## RESPONSES TO QUESTIONS DURING TENDERING

END OF ADDENDUM NO. 6

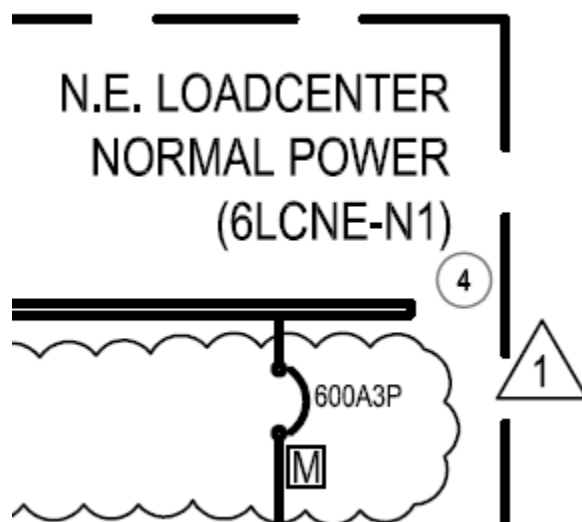
- Since you have mentioned electronic trip units in the metering section of the specifications, please confirm which breakers/feeders you are wanting metered. (I noticed there is a box with an "M" in it next to some of the breakers, please clarify what this means). Example:

All drawings that were issued under addendum 2 and has a tag M enclosed in square as per example shown indicates that Circuit Breaker is metered capable.
